Re: McDonald's Restaurant #7027 (Renovation)
520 Government Street, Dryden, Ontario

Re: Revision to SPA Drawings

DRAWING TITLE
EXTERIOR ELEVATIONS (DEMOLITION)

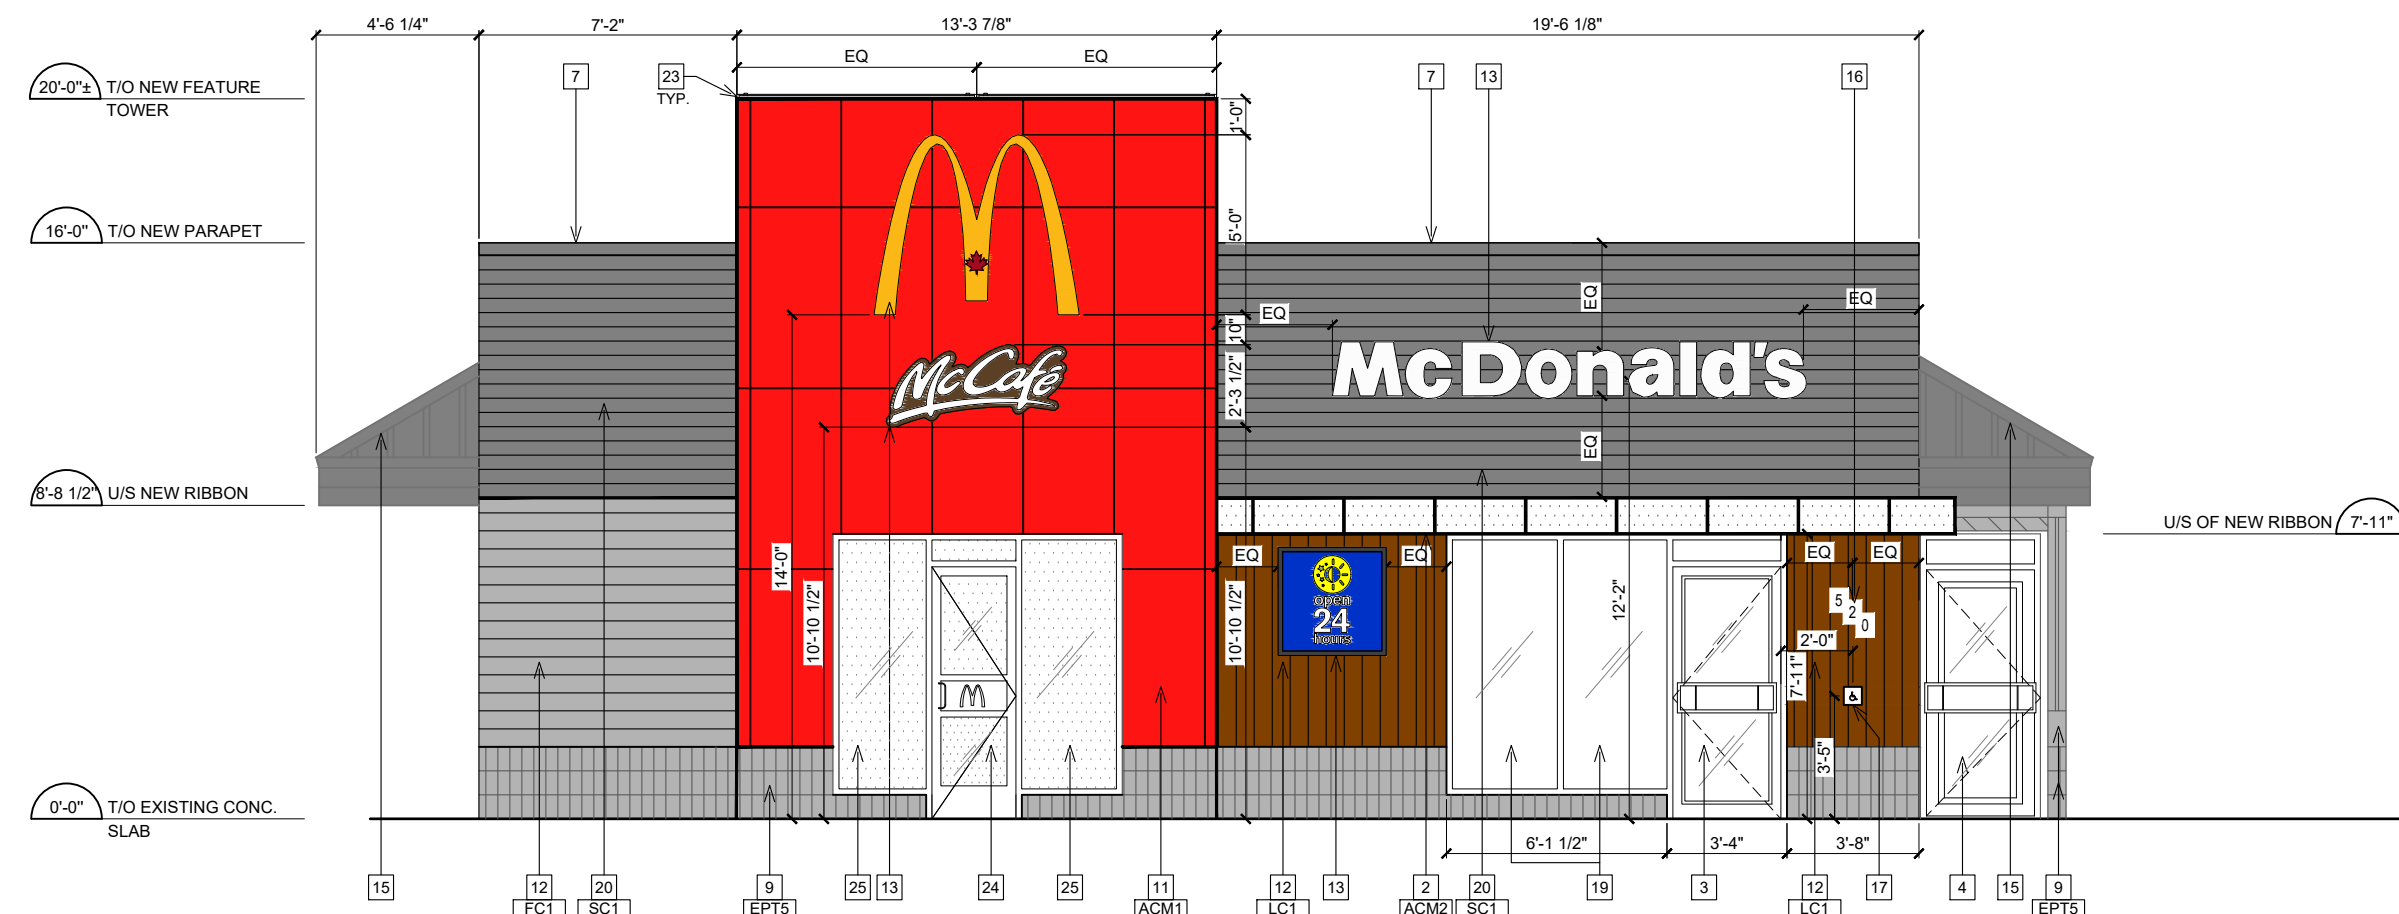
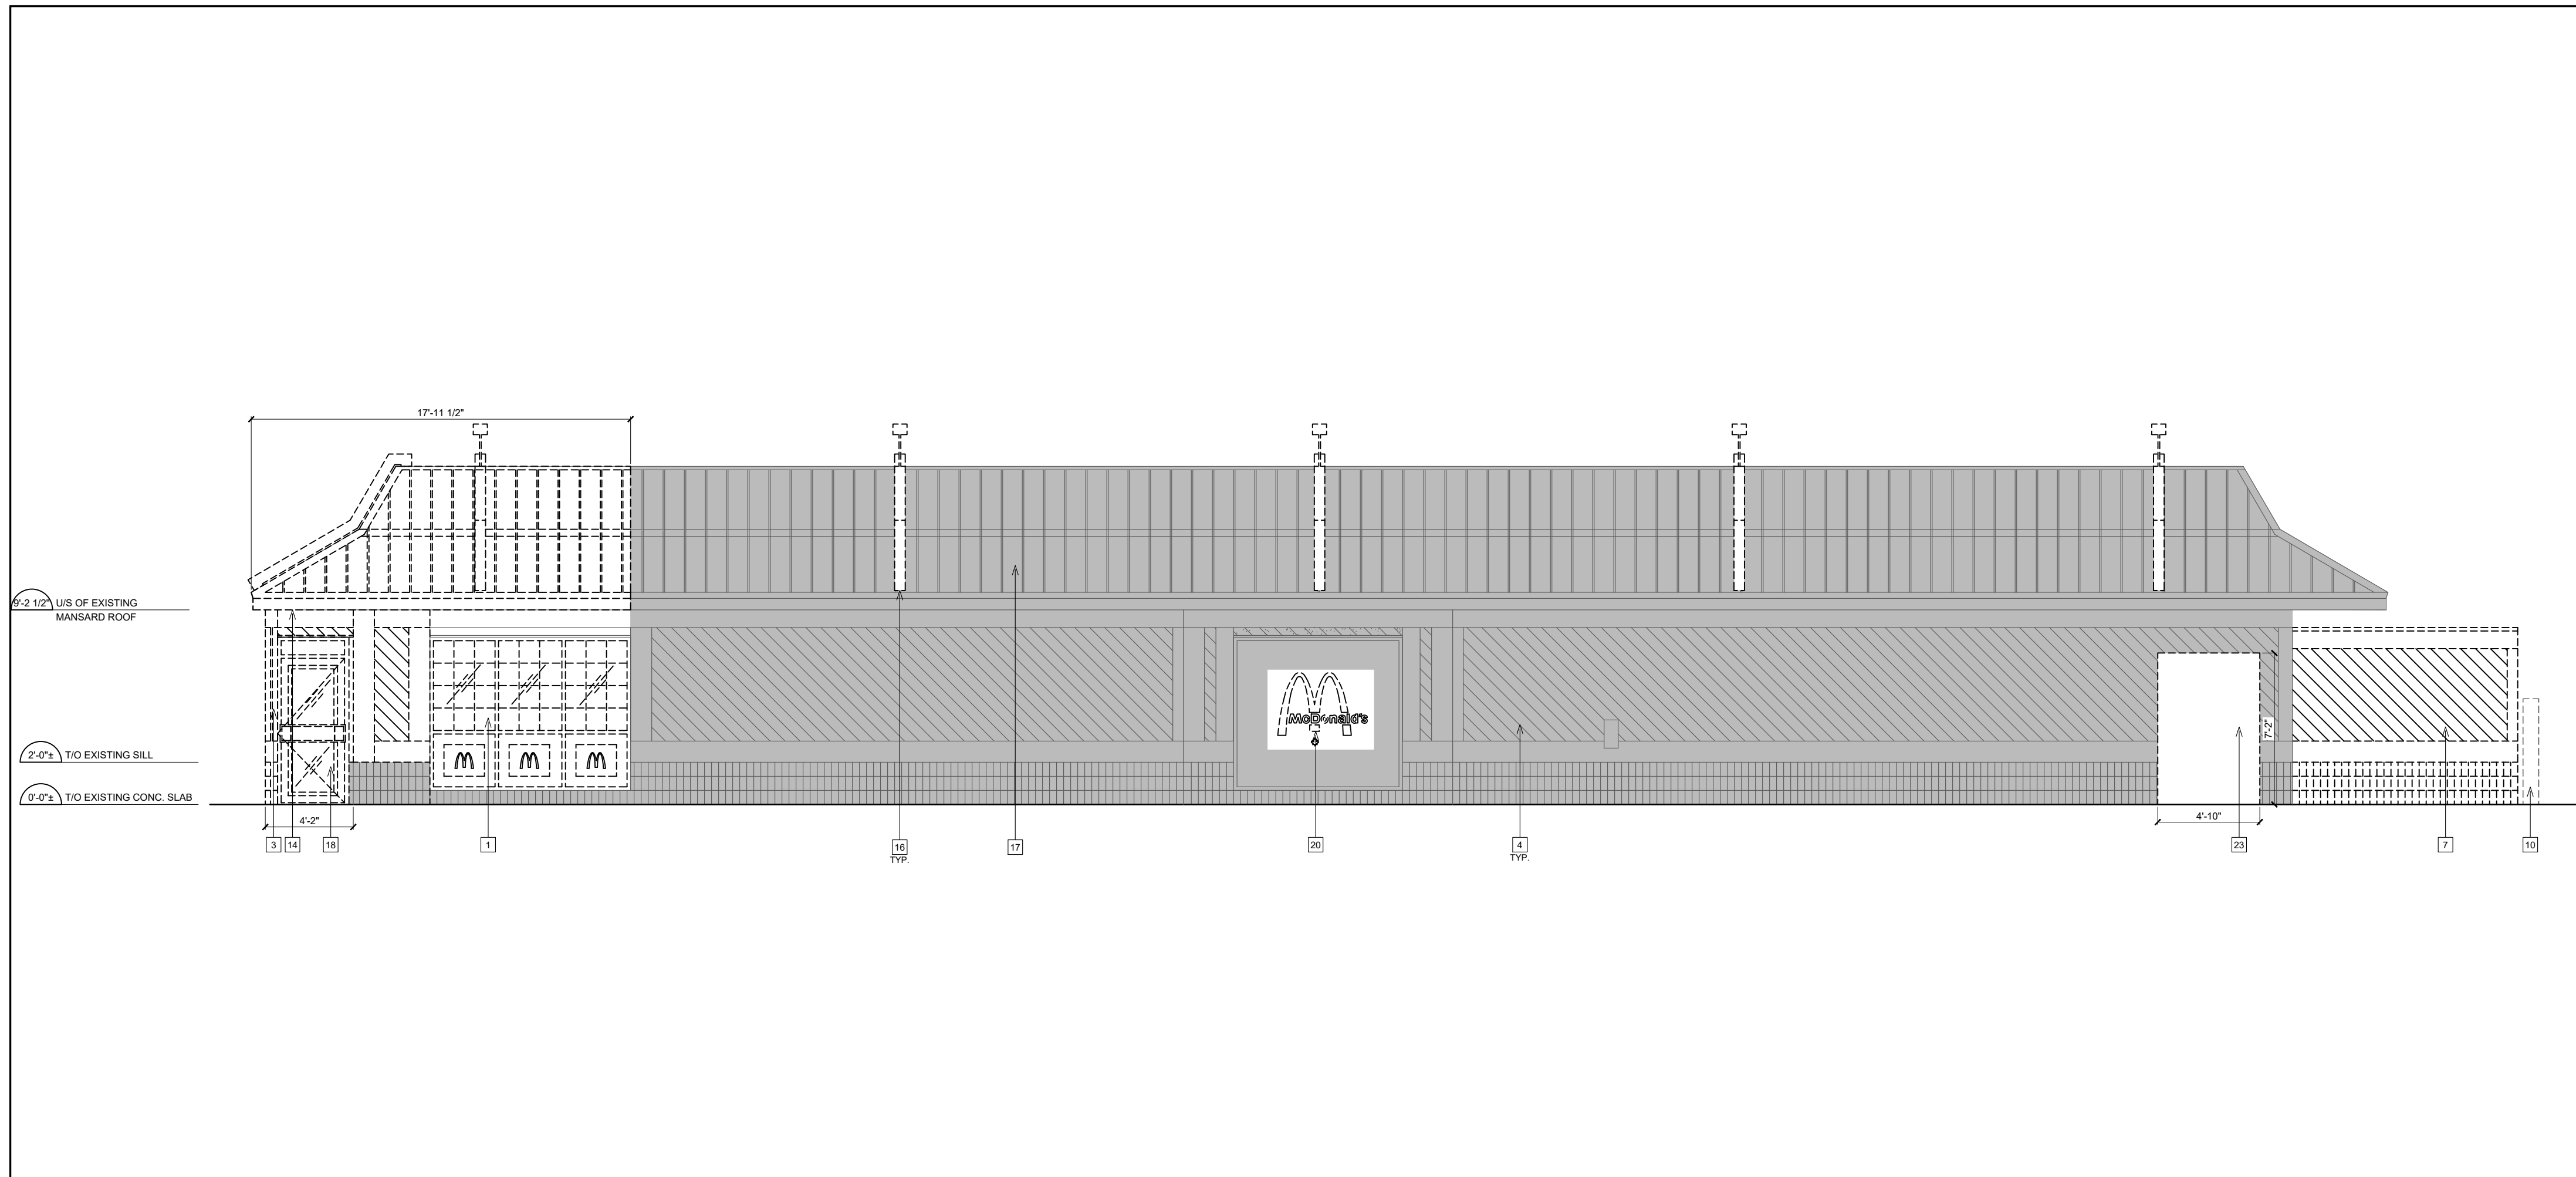
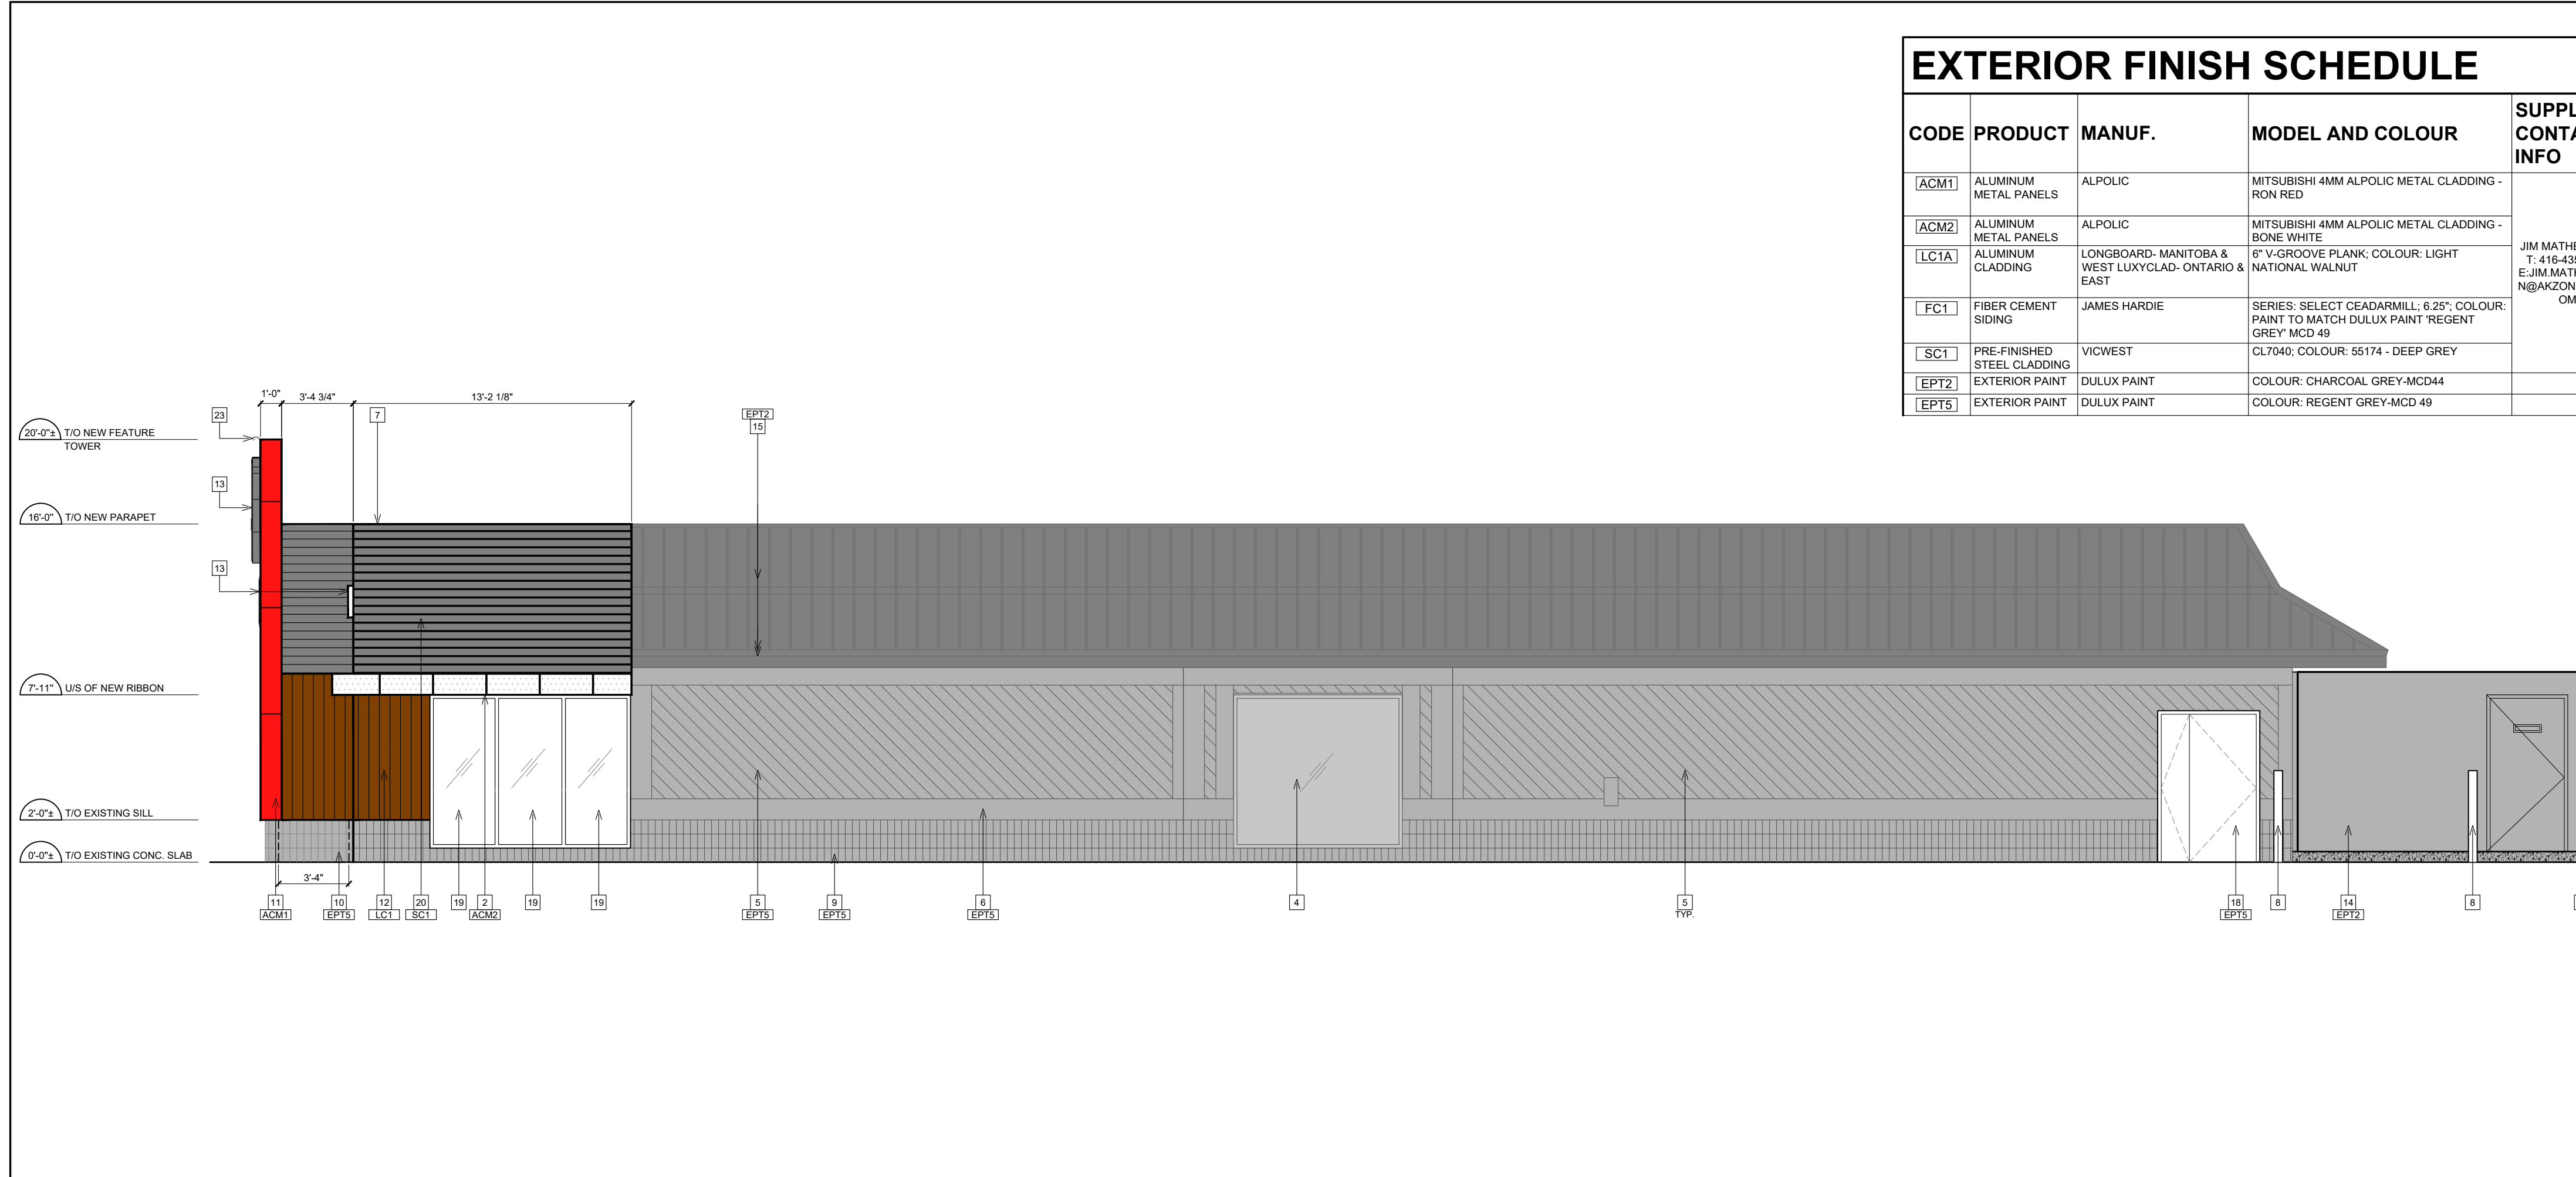
Item 2 Revision: Location and orientation of new proposed blade tower, complete with new signage and led lighting, revised on front elevation, and to be perpendicular to building. Refer to new Proposed Site Plan Note #45, and to revised Exterior Elevations 1/A5.0 and 2/A5.0, as shown.

Item 5 Revision: Refer to Exterior Elevations for revised barrier free public area door, BDAP door (1&2/A5.0) and new delivery door (1&2 A5.1) locations, as shown.

RPA PROJECT NO. 2408150 DRAWING NO. A5.3

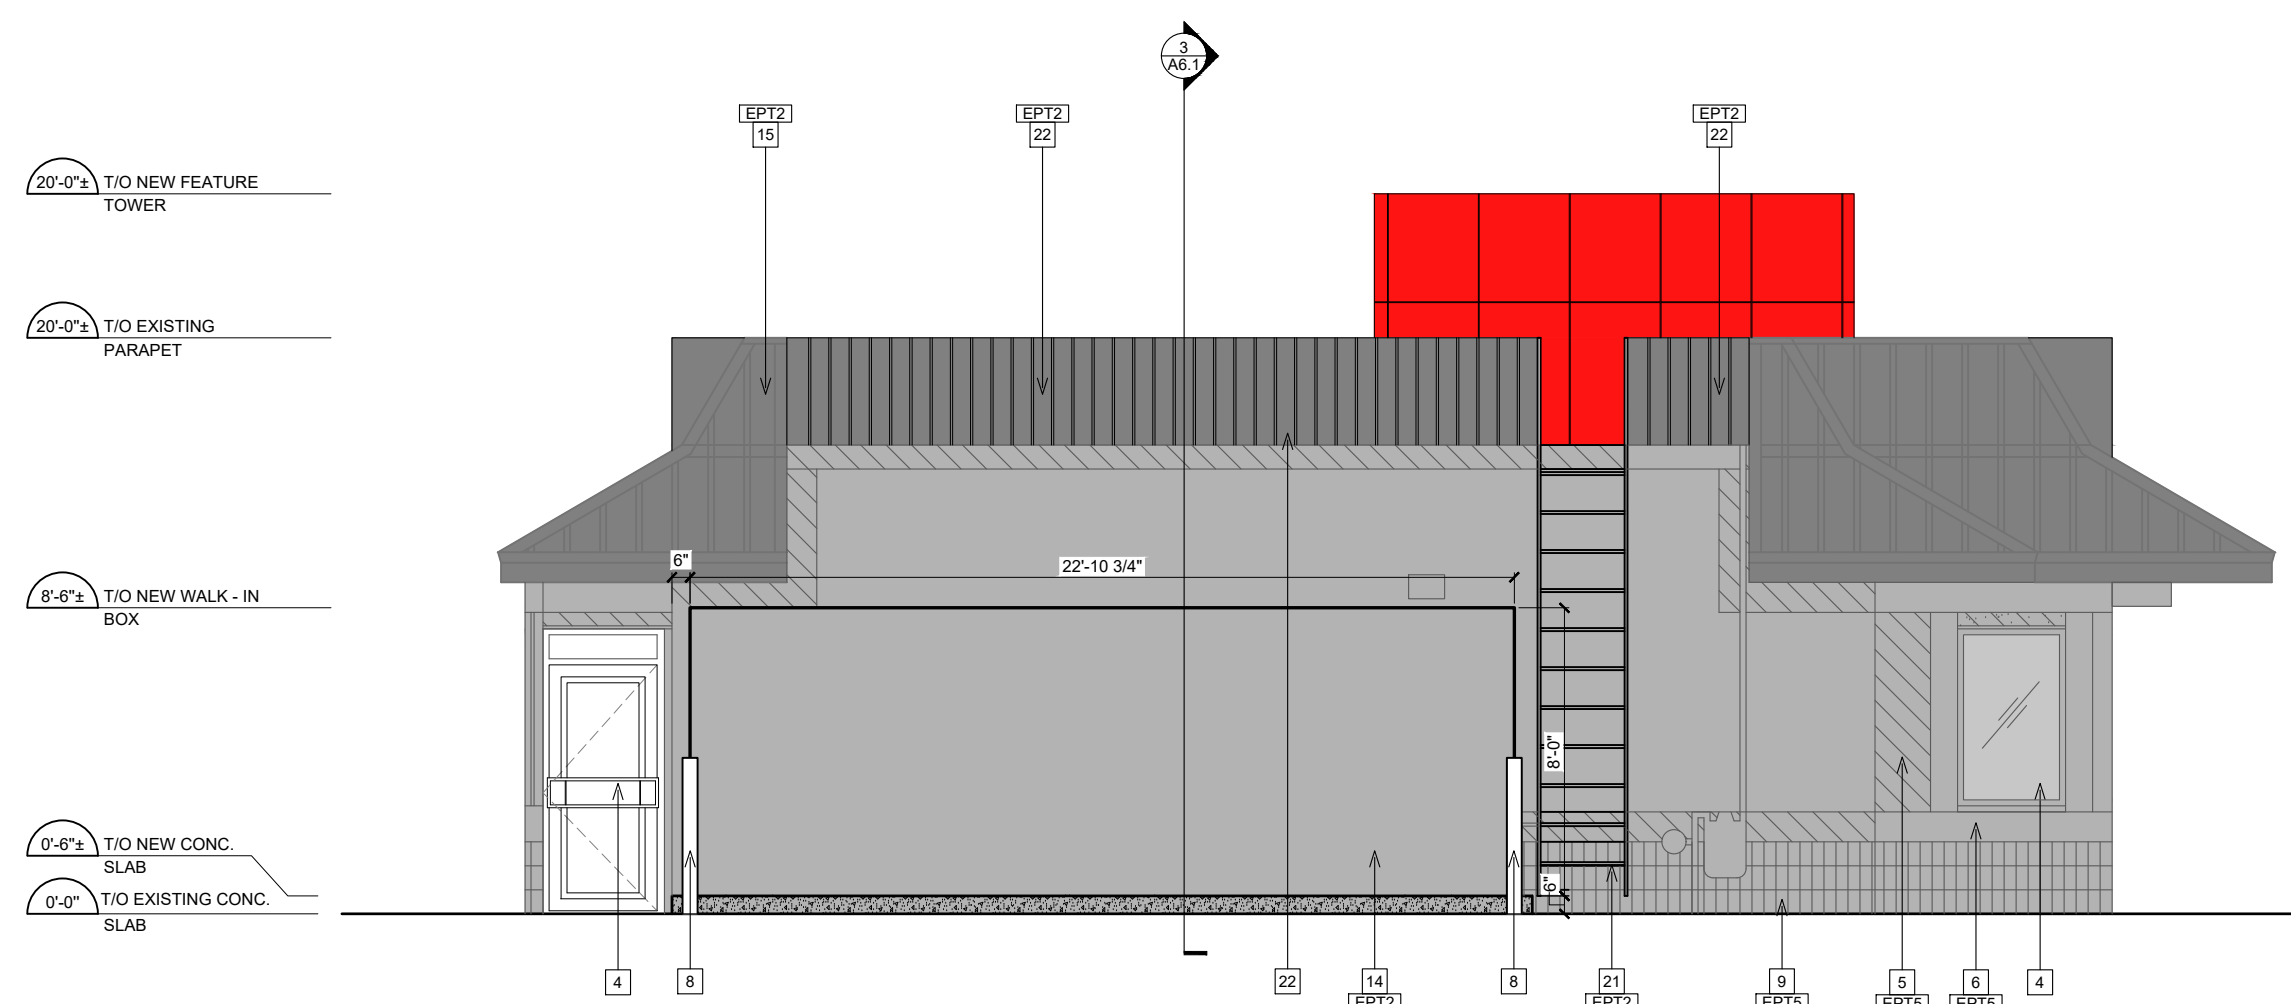
- a) *Front (North) Elevation existing cladding (partial on East and West Elevations) only to be stripped back to existing plywood sheathing to accommodate installation of new cladding materials. Refer to Proposed Site Plan Note #49 and to Exterior Elevations, as shown, for new extent and finishes.*
- b) *Remainder of building existing cladding (stone base and siding) to remain and be repainted. Refer to revised Exterior Elevations and Exterior Finish Schedule for extent of work and finishes.*
- c) *Existing wood fence boards at rear of the building (serving as roof screen) to be removed and replaced with new to match existing; to be painted to match roof paint finish proposed. Refer to Exterior Elevations 1/A5.3 and 2/A5.3, as shown.*
